ITB B24-PW-103006-500431 Lake Havasu Police Department Rehabilitation Project ADDENDUM NO. FOUR December 7, 2023

ITEM	ACTION	DESCRIPTION or ISSUE
1	Clarification	Question & Answers arising from Second Pre-Bid Meeting & Job Walk
2	Clarifications	Additional Plan Sets Attached

A3.01

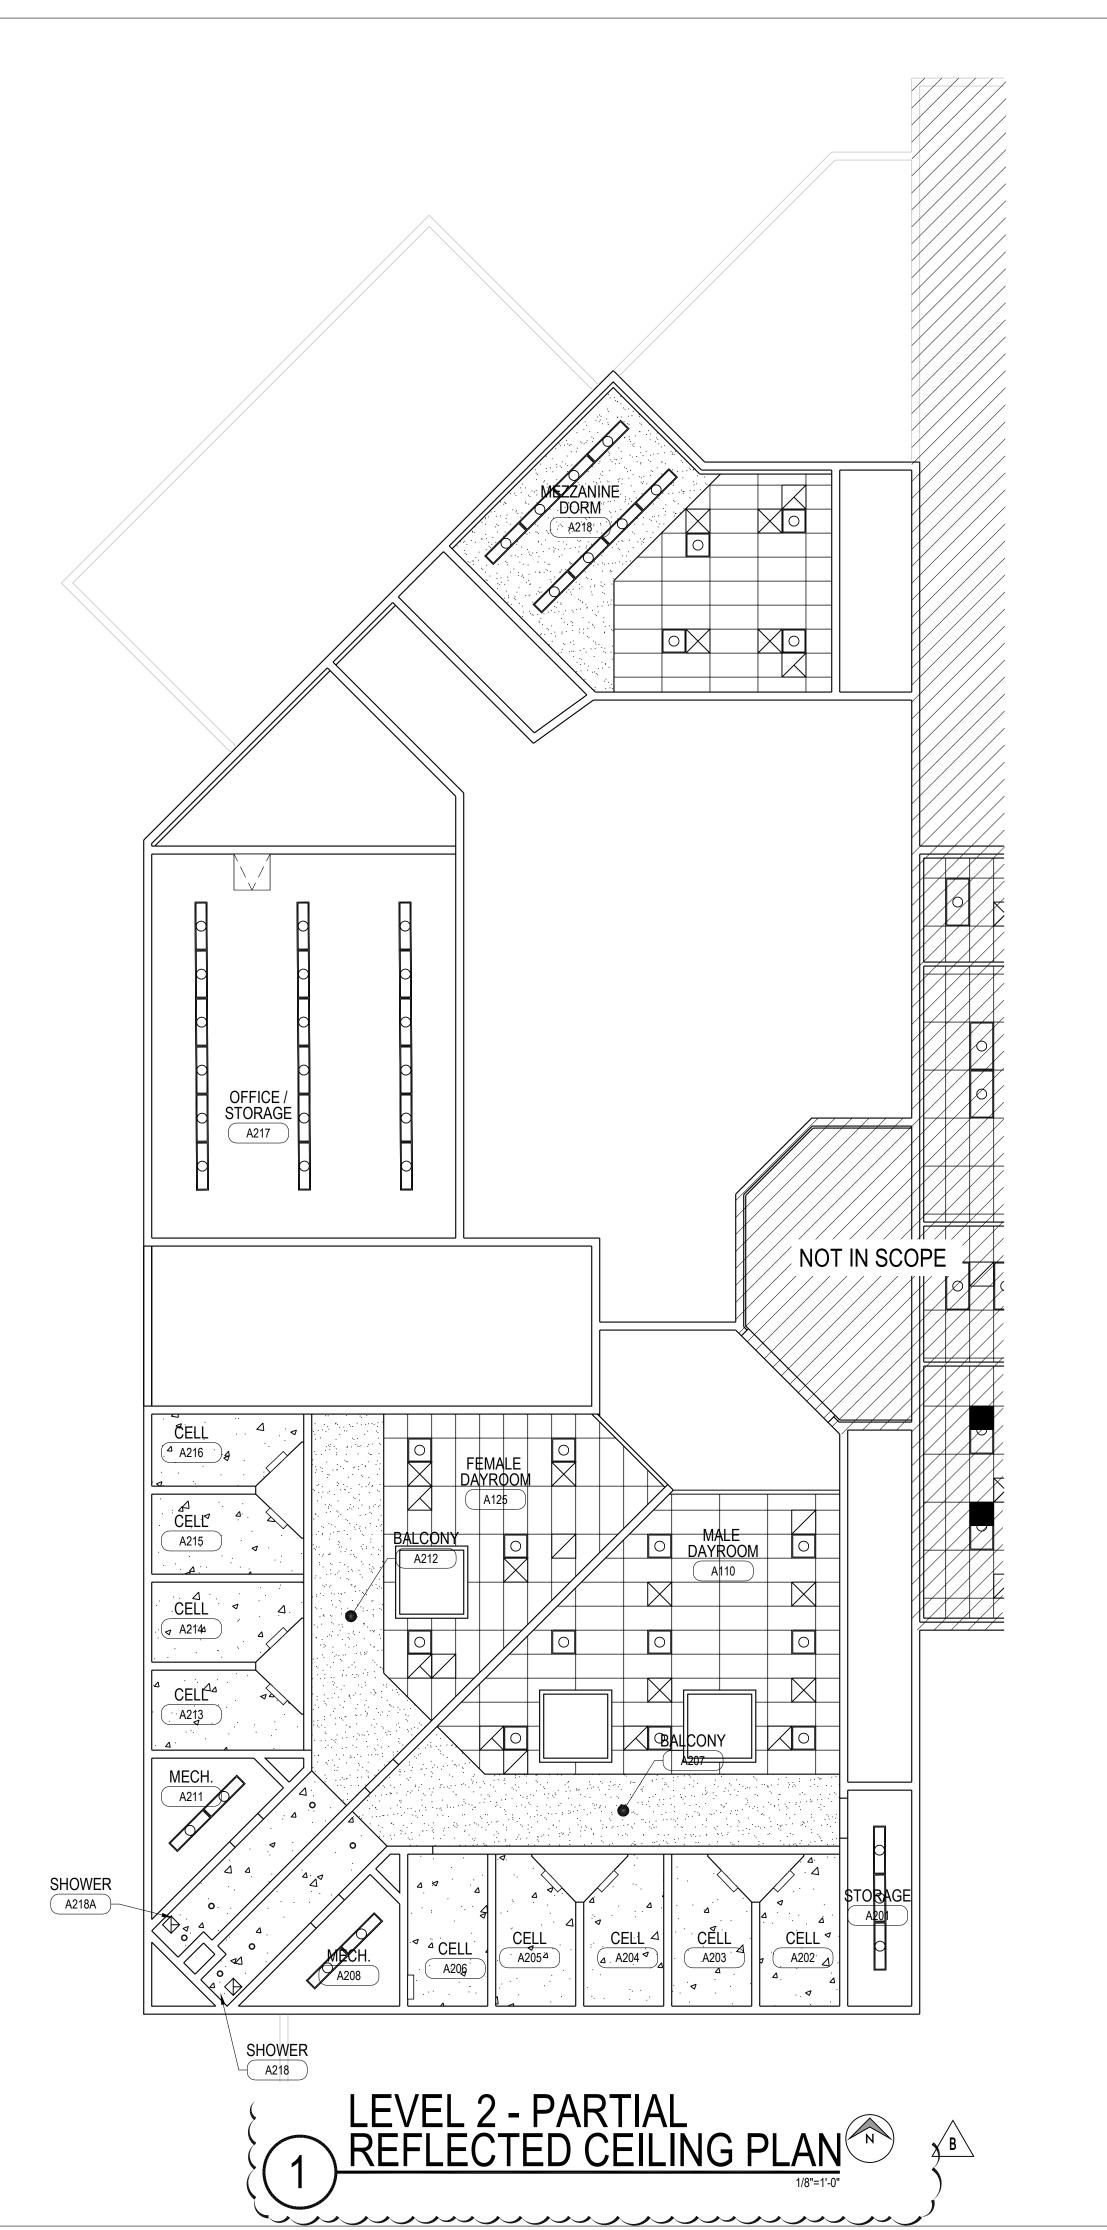
3. Are there ceiling plans/specs referencing T-Bar vs Hard lid

See plan sheet in Addendum 4 - A301 & A302

S2.3

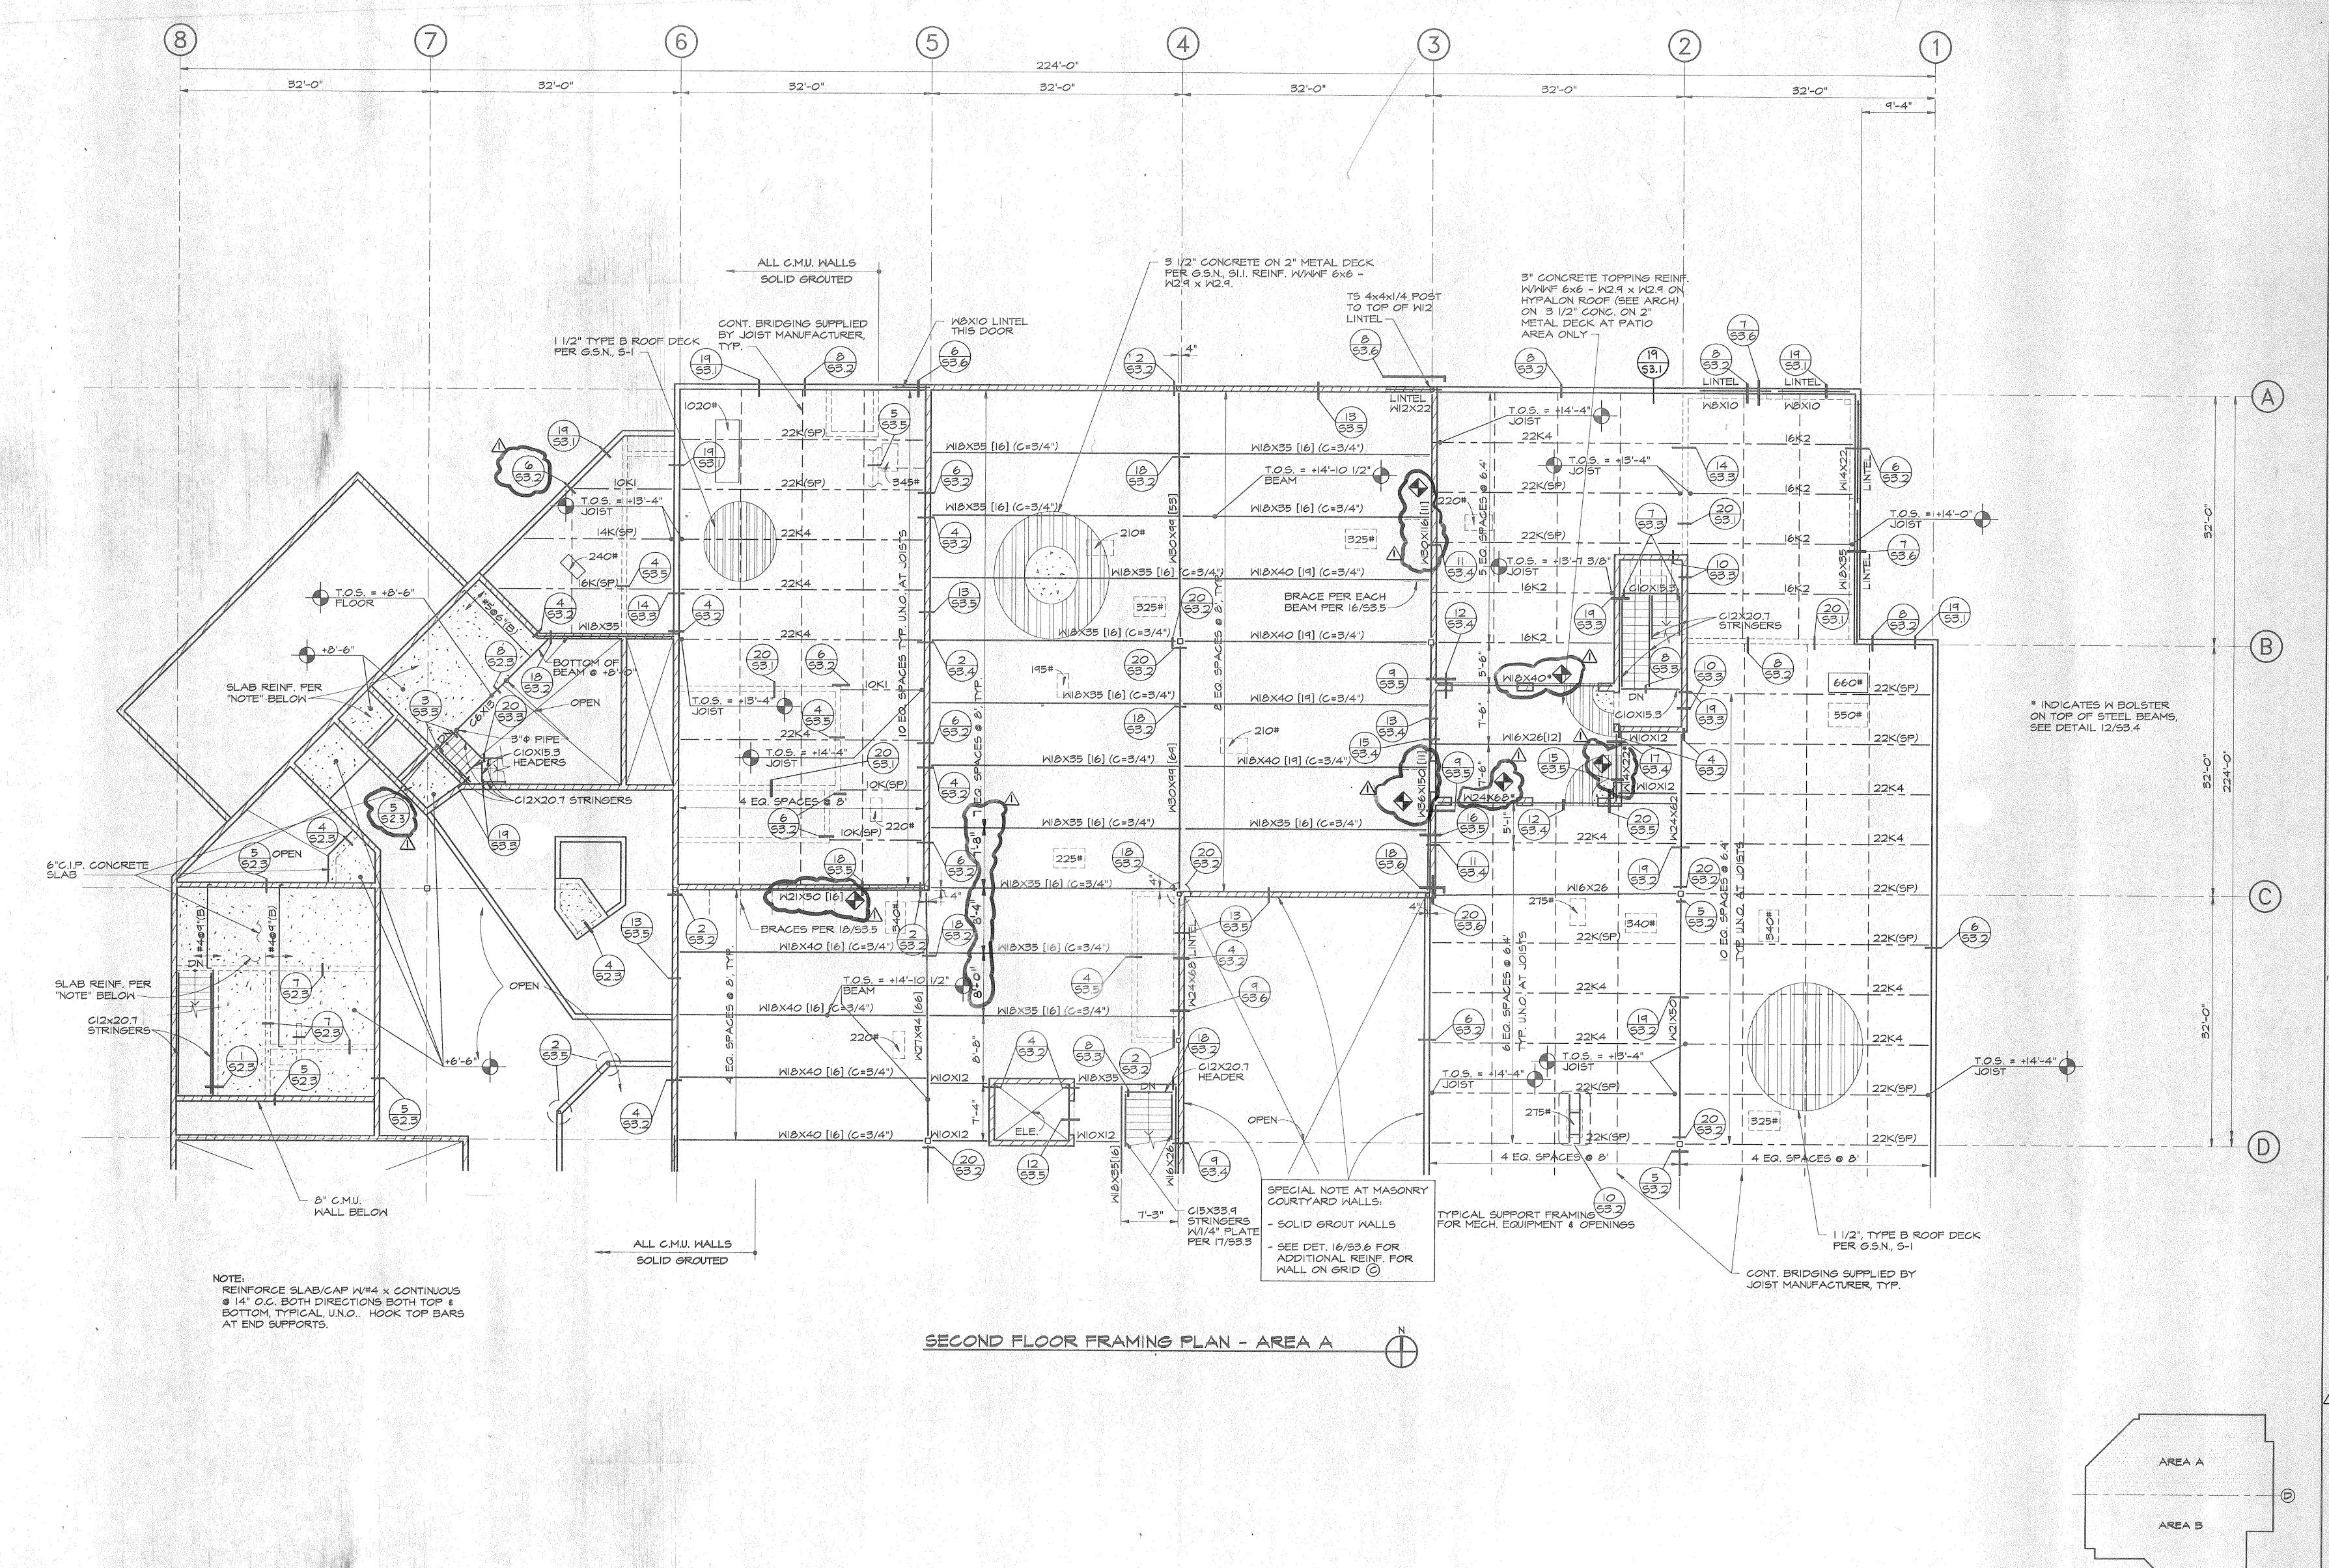
7. Thickness of slab in the jail area?

See sheet S2.3 of existing structural Drawings attached.
